Memorandum

Subject: BMA Goonyella Riverside and Broadmeadow Mine PRCP – Information Request Response EPML00853413

BMA Goonyella Riverside and Broadmeadow Mine PRCP Information Request Response

The purpose of this memo is to address the Information Request Notice relating to the Progressive Rehabilitation and Closure Plan (PRCP) for Goonyella Riverside and Broadmeadow Mine (GRM and BRM) – environmental authority (EA) EPML00853413.

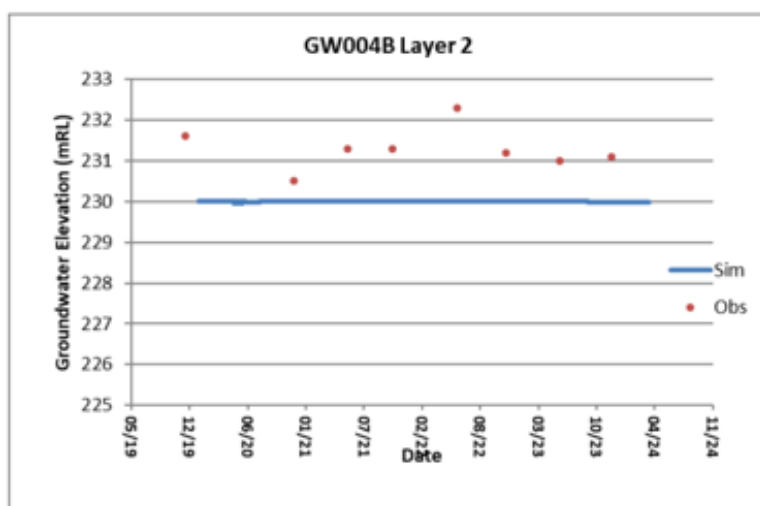
Item	PRCP Plan/ Schedule	Issue	Required Information
Groundwater Modelling			
5	Groundwater use, Appendix D Hydrogeology, section 7.3.4.3	Groundwater extraction volumes The section states that, ‘<i>The goaf K and S parameters were adjusted by comparing computed extracted groundwater volumes from the goaf areas to the measured and recorded groundwater ingress pumped from the underground between 2018 and 2023</i>’. Apart from an estimated groundwater inflow to Broadmeadow underground for 2020-21 in Table 16 there does not appear to be any measured and recorded groundwater ingress pumped from the underground between 2018 and 2023 provided in the report. These figures should be provided to demonstrate how the model was able to simulate these figures.	Provide a revised Appendix D inclusive of - a) Measured and recorded groundwater ingress pumped from underground between 2018 and 2023; and b) A comparison of recorded ingress with the model stimulated extraction volumes.

- a) The groundwater ingress pumped from the underground workings between 2018 and 2023, which has been used in the groundwater model is as follows.

Financial Year	Volume (ML)
2019	310
2020	332
2021	247
2022	570
2023	490

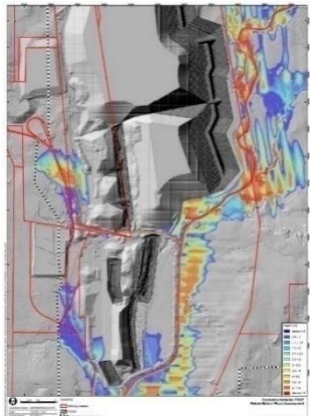
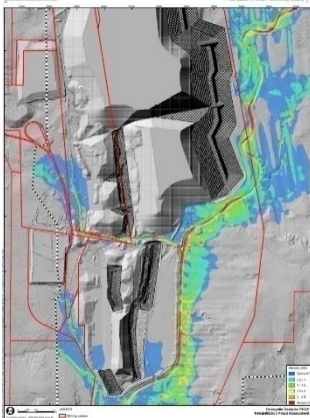
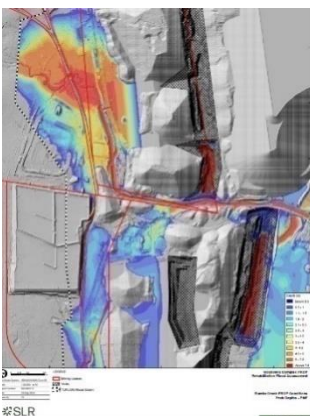
Item	PRCP Plan/ Schedule	Issue	Required Information
13	Appendix O Void closure plan	Goonyella residual void modelled depth and average water level Appendix O appears to provide no detailed information about the elevation of the base of the Goonyella residual void used in determining the modelled average void water levels. In Appendix D, Section 15.4.2.6, in relation to Goonyella residual void northern section initially, and then the middle section of the void, it states: <i>'Note: The pit floor is some -35 mAHD at this location, the pit floor adopted in the residual void (surface water) water balance model is set at a uniform -45 mAHD (it is assumed that the specialist modellers used the deepest pit floor elevation in their water balance model).'</i>	Provide a revised Appendix O inclusive of - a) Clarification if the modelling of Goonyella residual void with a uniform base is considerate of proposed backfill of the void at the northern end; and b) Information on how the modelling of Goonyella residual void with a uniform base of -45 m AHD may impact the modelled average void water level and the void behaviour predictions as a sink.

Item	PRCP Plan/ Schedule	Issue	Required Information
		This results in the water level dip or decrease at the start of the water level hydrographs when the groundwater model drain cells (at bottom of pit) are changed to CHD and adopt the predicted water balance model pit water levels (Section 15.4.1). This dip in the water level hydrographs is recognised in all of the hypothetical observation point hydrographs. This is particularly evident in the middle set of hydrographs where the Goonyella open cut mine only extends to a depth of around 25 mAHD in this area (mining is shallower in this area due to environmental constraints in this area). It appears then that the Goonyella residual void has been modelled in Appendix O as having a uniform void base of -45 m AHD when in places it will be higher than this and in the middle as high as +25 m AHD. It is not clear how this has impacted the modelled void water level? Is it possible that by using a deeper base for the void, than actually will exist, the modelled void water level is lower than that which will actually result. The PRC plan section 4.3 states that Goonyella void will be partially backfilled at the northern end, it is not clear if the above modelling has considered the void base after the intended backfill level. Further clarification is needed to understand how the consideration of deeper base for void and partial backfill of the void for flood mitigation purposes might impact sink/ source relationships.

- a) No revised Appendix O is required as all the modelling includes the proposed backfill of the voids, including the void at the northern end.
- b) The groundwater model is constructed to include actual final void depths and variations in pit floor elevation along the entire Goonyella Pit, including the shallower section.

The initial groundwater model run (Model Run 1) used drain cells at the base of the Goonyella Pit (final mine depths), such that groundwater ingress was provided for use in the water balance model (WBM) for the maximum groundwater ingress when the final void is dewatered (dry). These predictions were used in the WBM model to provide a simulated pit water level (referred to as Rev B) in Section 15.4.1 of the PRC plan Hydrogeology Assessment report (Appendix D). Thus, the groundwater model did not over predict ingress due to a uniform (-45mRL) floor.

Noting that the predicted residual void water level is >100m deeper than groundwater levels across the model domain, the relatively small variations in floor depth will not have a material impact on the model predictions and the void will remain a strong groundwater sink.

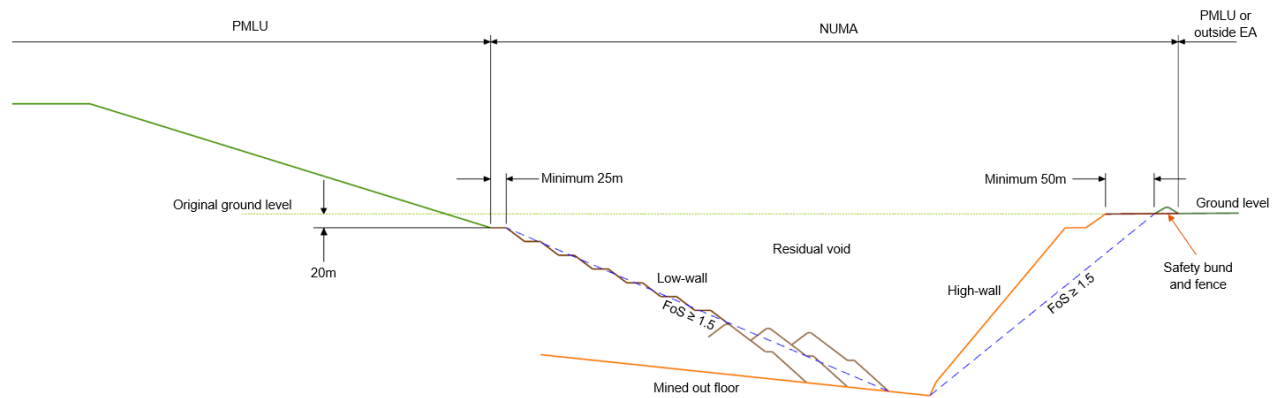
Item	PRCP Plan/ Schedule	Issue	Required Information
25	PRC plan s1.4.4	Existing Rehabilitation The PRC plan in Table 18 and section 1.4.4 indicates that progressive rehabilitation commenced in 1990. However, it is not clear from the information provide when any of the rehabilitation works were completed. Other details about the existing rehabilitation areas are limited, and further information is required to understand the current condition of these areas. This information is important to ensure that any maintenance or repairs of existing rehabilitation are adequately captured by the PRCP.	Provide a revised PRC plan section 1.4.4 to: a) Clarify the mine domains that are included in the existing rehabilitation area, b) Discuss the relevancy of RM2 (Remediation) to existing rehabilitation areas, c) Include an approximate timeline of when each rehabilitation activity was commenced and completed for the existing rehabilitation area that corresponds to the proposed rehabilitation milestone, d) Clarify the current status of existing rehabilitation in terms of meeting compliance with rehabilitation milestones it has been subjected to so far; and e) Identify any re-work required for any particular rehabilitation milestone to progress to demonstrating achievement stable PMLU.

- a) The mine domain of RA7 was dams. The mine domain of RA10 was spoil dumps.
- b) The RM2 (remediation and/or management of contaminated land) was not a requirement when existing rehabilitation was executed. Rehabilitation was undertaken to achieve the EA Table E1 rehabilitation requirements. The inclusion of RM2 for spoil dump rehabilitation is a new requirement that was included in the Saraji Mine PRCP, approved in October 2024. The likelihood of spoil dump rehabilitation requiring remediation for contamination is low as activities with the potential to cause contamination (such as refuelling or chemical storage) are generally not undertaken within spoil dump areas. However, if routine rehabilitation monitoring identifies any potential contamination concerns, further investigations will be undertaken and appropriate mitigation measures implemented, if required.

c/d/e) Additional information on the existing rehabilitation is detailed in the table below. As detailed in PRC plan Section 1.4.4, several areas of existing rehabilitation have not been included in the PRCP schedule. One reason for excluding existing rehabilitation areas was because substantial corrective action would be required to achieve the nominated PMLU, and in some case the planned PMLU was changed to better align with the landforms and surrounding PMLUs. Existing rehabilitation areas assessed as on track to achieve the next rehabilitation milestone have been included in PRCP and scheduled accordingly.

Figure 3.1: 3D void design plan: an overview of GRBM residual voids and void lakes at the end of the water balance model simulation

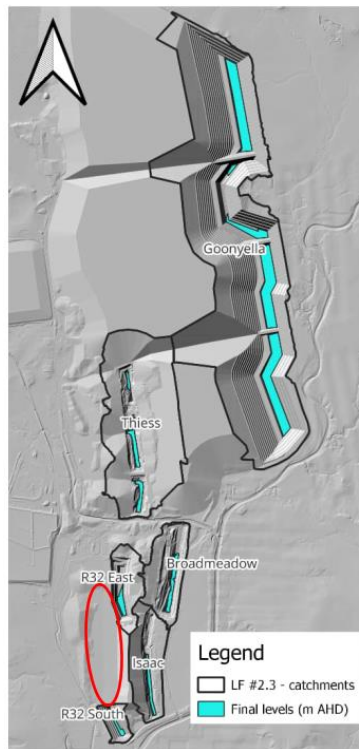
Item	PRCP Plan/ Schedule	Issue	Required Information
28	PRC plan section 4.3 and s6.1.1.2	Discrepancies in the provided information Section 4.3 states that the Ramp 2 (Airstrip void) will be completely backfilled above the tailings (R32 TSF). Section 6.1.1.2 confirms that this complete backfill aims to form a stable and free-draining landform, addressing concerns related to hydraulic gradients, flood ingress, and potential contamination. However, in the final landform map of the PRCP, Ramp 2 is still shown as a residual pit (see below image). This inconsistency requires clarification to ensure alignment between stated plans and the final closure design. 	Provide a revised PRC plan that – a) Clarifies the inconsistency between the PRC plan sections and the final landform map regarding the backfill status of Ramp 2, and b) Revises the final landform map to show backfilled ramp 2.

No revision to the PRC plan was required as the information in the plan and Appendices is correct.

- a) The residual void circled in the RFI issue is the R32 East void. Airstrip void is located directly to the west/south-west and this void is backfilled above the tailings. Figure 3.1 from the Void Closure Plan (Appendix O) is shown below with R32 East void labelled and the backfilled Airstrip void circled in red. Ramp 2 is not referred to in the PRC plan.
- b) The R32 East residual void is planned to remain, therefore the landform map in the PRC plan Section 6.1.5 and the various appendices are correct.

Figure 1: Representation of Cross-Sectional Mean vs 2D Grid Results in Eureka Creek

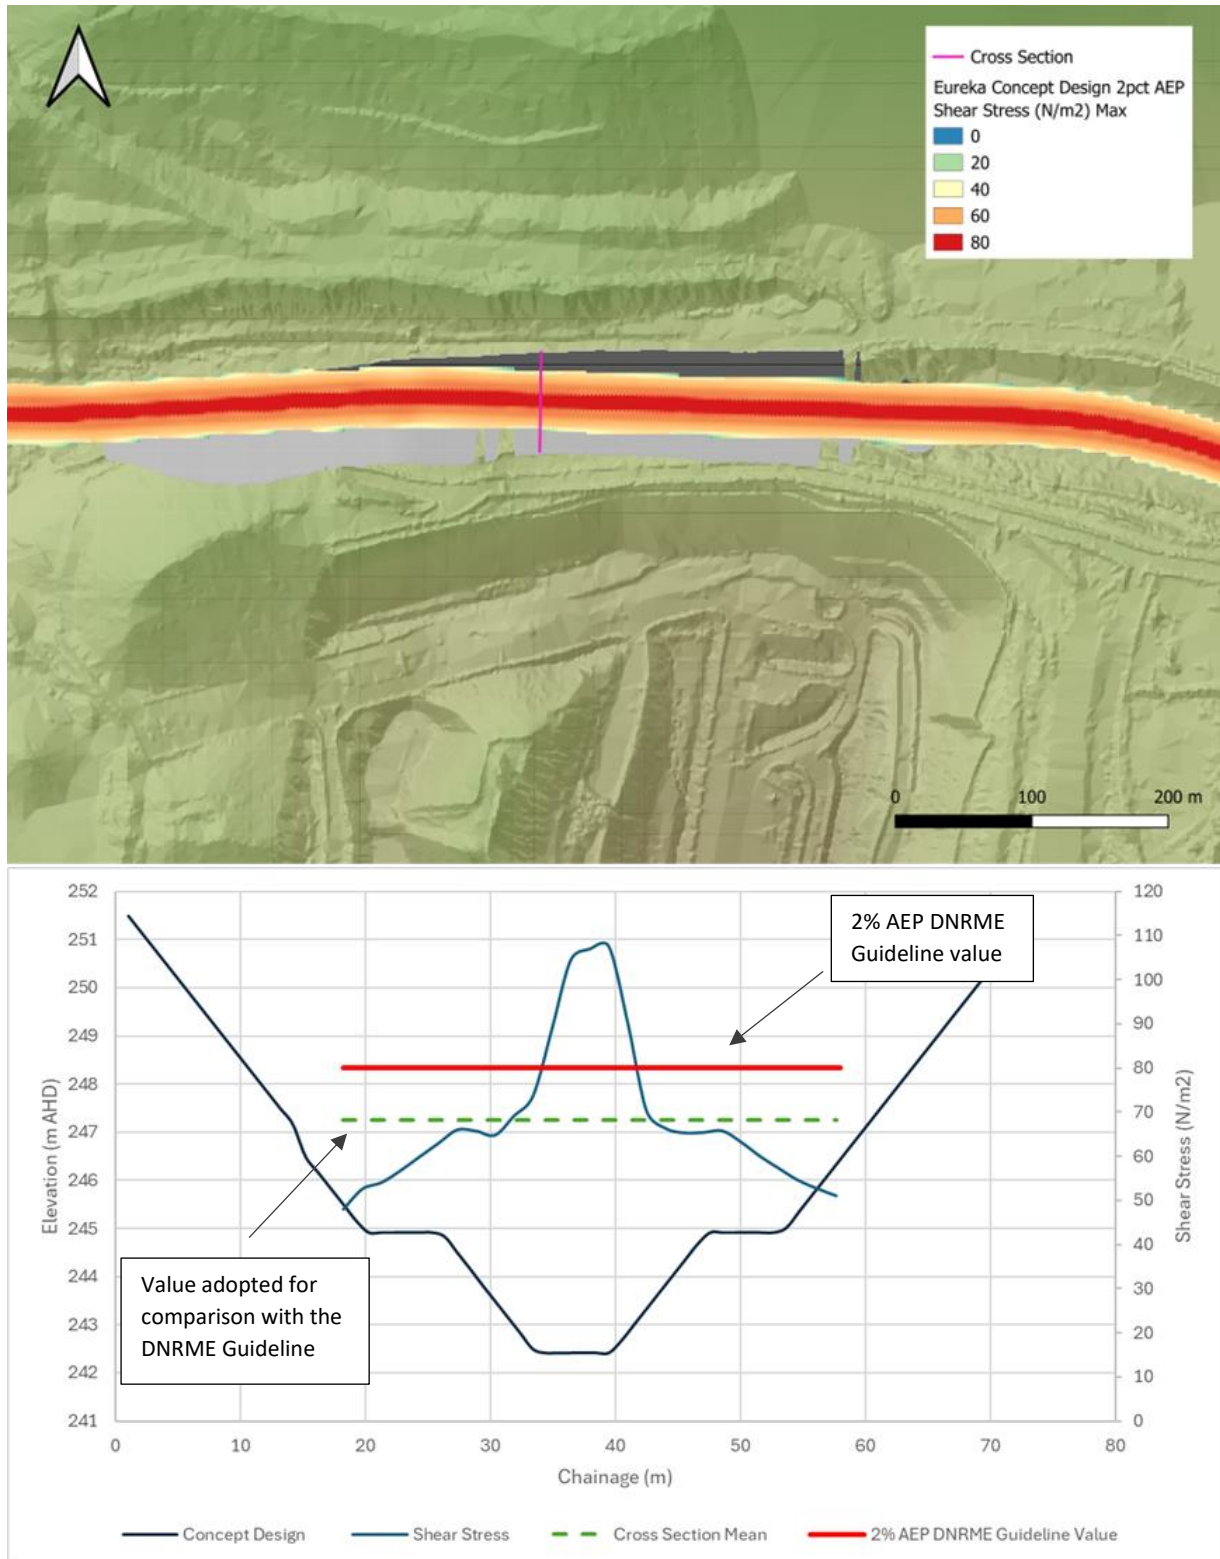
Item	PRCP Plan/ Schedule	Issue	Required Information
15	Appendix H Rehabilitation flood modelling Section 5.5.1, 5.5.2	Flood flow force along diversions The Appendix H shows that shear stress in Eureka Creek exceeds 80 N/m² during even a 2% AEP flooding, which poses a significant risk of ingress into Ramp 2 void. Further, under PMF conditions, there is confirmed ingress into Ramp 2. It seems the presented maps, assume stability of the diversion during 2% and 0.1% AEP, despite high erosive forces, and assumes stability of the diversion in the PMF event even in the case of overtopping. The <i>Watercourse Diversion Guideline</i> mandates integration of sediment regimes into analysis, which appears to be absent. Sediment hydraulic forces should be clearly considered in the modelling to completely understand the risks to the landform during flood event. Also, in relation to Ramp 2, it is important to clarify whether tailings material will be present and exposed to ingress. The PRC plan should address PMF design for closure, per the mandated requirements of ANCOLD 2012.	Provide a revised Appendix H inclusive of – a) A detailed analysis of how high shear stresses (>80 N/m²) are managed to prevent erosion and void ingress during 2% and 0.1% AEP events, b) Modelling that considers sediment hydraulic forces using the TUFLOW sediment module; and c) Mitigative measures to prevent ingress and subsequent contamination, in relation to any tailings material present for Ramp 2.

TUFLOW outputs results in a 2D grid, for a nominated grid cell size. To provide a cross-sectional mean comparison with the threshold values listed in the ACARP and DNRME Guideline, a cross-sectional mean was taken along the TUFLOW 2D grid output. A visual representation of this discrepancy can be seen in Figure 1. As such, 2D flooding outputs, like those in Appendix H, don't represent the cross-sectional values compared against the threshold values specified in the DNRME Guideline.

Figure 2: Example of Terrace Formation by Channel Incision (Fisher Stewart, 2000)

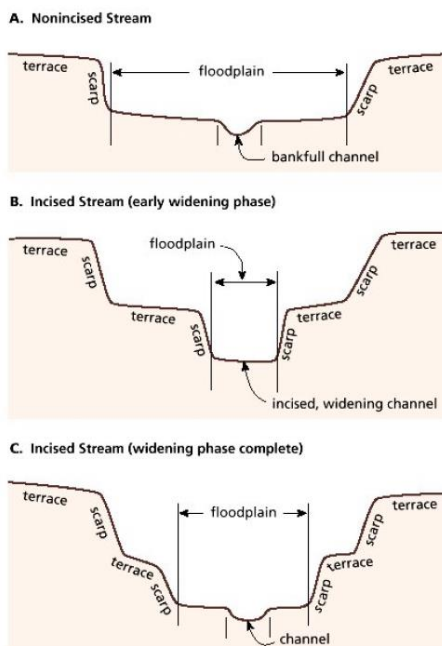
Item	PRCP Plan/ Schedule	Issue	Required Information
19	Appendix K, M, N, L Concept design reports for Isaac, Holding Paddock, Fisher and Eureka Creek	In accordance with the <i>Watercourse Diversion Guideline</i>, the proposed diversions must: - maintain the natural hydrological and hydraulic characteristics of the original watercourse, - maintain natural geomorphic and riparian vegetation similar to the original watercourse, - maintain a sediment transport regime, with minimal impact on sediment deposition or erosion, - achieve equilibrium condition, - minimise erosion, and do not increase flood risks. - provide an appropriate floodplain corridor width to accommodate natural processes - be designed to be self-sustaining, with minimal ongoing maintenance, - be integrated into the overall rehabilitation plan. - be considered in floodplain modelling regarding the impact of diversions on flood behaviour, ensuring stability of the final landform design. - have structural stability analysis if is located through spoil - be designed to be hydraulically and structurally stable e.g., armouring The proposed rehabilitation criteria for diversions and given information through the concept design reports lack adequate provisions for –	Provide revised PRC plan/relevant appendix inclusive of information on – Rehabilitation criteria for creek diversion addressing: - floodplain width, - prevention of floodwater ingress to nearby landforms, and - structural and erosional stability of diversion banks.

Eureka, Fisher, and Holding Paddock Creek diversions are all 1st to 3rd stream order incised creeks. In the Bowen Basin, incision lowers the bed level of the creek forming terraces as this process repeats (Fisher Stewart, 2000). Terraces left by the incision process will often become floodplains of incised creeks in the Bowen Basin. This process is displayed in Figure 2.

Figure 4 Landform 2.3 Additional Flood Immunity

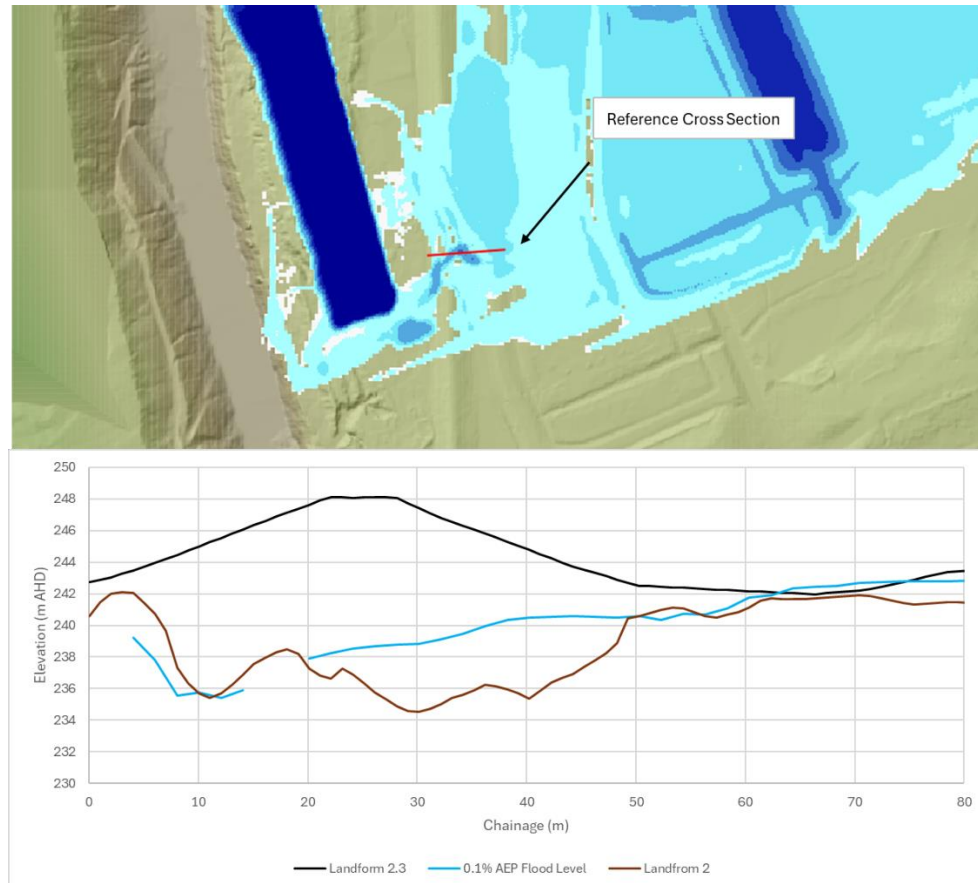
Item	PRCP Plan/ Schedule	Issue	Required Information
16	Appendix H Rehabilitation flood modelling Section 5.5.1	Flood ingress into pits and interaction with TSF The PMF scenario results in void ingress, i.e., into Ramp 2 (airstrip), Goonyella pit, and R32 Satellite (APPENDIX B1-2-4, APPENDIX B3-2-4). With respect to the interaction of flood waters with the TSF and void, section 5.5.1 states that the R32 residual void is subject to inundation from the R32/Airstrip TSF facility rehabilitated surface to the north and Isaac River from the south in PMF events. In conclusion, PMF influences and inundates TSF R32 and R32 Satellite pit (APPENDIX B1-2-4, APPENDIX B3-2-4). To ensure compliance with section 126C(1)(j) of the <i>Environmental Protection Act 1994</i>, provided information must demonstrate how the final landform is designed to be safe and stable. Information expanding on whether the ANCOLD 2012 guideline has been considered, and an explanation on how the design flood was considered for protecting TSF to avoid environmental risks will help in demonstration of safe, stable final landform design. Risk management strategies for void ingress under PMF conditions must be clearly explained, including measures for minimising flood ingress and mitigating associated risks of contamination with specific reference to waste material characterisation is needed.	Provide a revised Appendix H inclusive of – a) Consideration to ANCOLD 2012 guideline and explanation on how the design flood was considered for protecting TSF to avoid environmental risks, b) Risk management strategies for void ingress under PMF conditions, c) Management measures to minimise flood ingress; and d) Mitigative measure for contamination risk in consideration to ingress and in-pit waste material characterisation.

As part of the concept diversion designs, flood impacts of the 0.1% AEP event were modelled to determine potential adverse interactions with the final landform. Eureka, Fisher, and Holding Paddock Creek diversions were all modelled to prevent ingress into the adjacent final voids. Results from 0.1% AEP flood modelling along the Isaac River concept design indicate flow ingress into Ramp 0 and Ramp 2, located west of the diversion. It's important to note that these results are based on landform version 2. However, the latest landform version 2.3 includes flood protection measures that mitigate this risk. A cross-section representation of landform version 2.3 against the 0.1% AEP results for landform 2 is presented in Figure 4. As can be seen landform 2.3 provides an additional 6 m during a 0.1% AEP event, providing flood immunity to the void.

It should be noted that these flood modelling results are for the purposes of diversion design and should not be considered the final flooding results for the GRM and BRM PRCP. These results are provided in Appendix H of the PRCP. The diversion design has not been included in Appendix H, however, flood modelling indicates ingress into the final voids will not occur during a 0.1% AEP event.
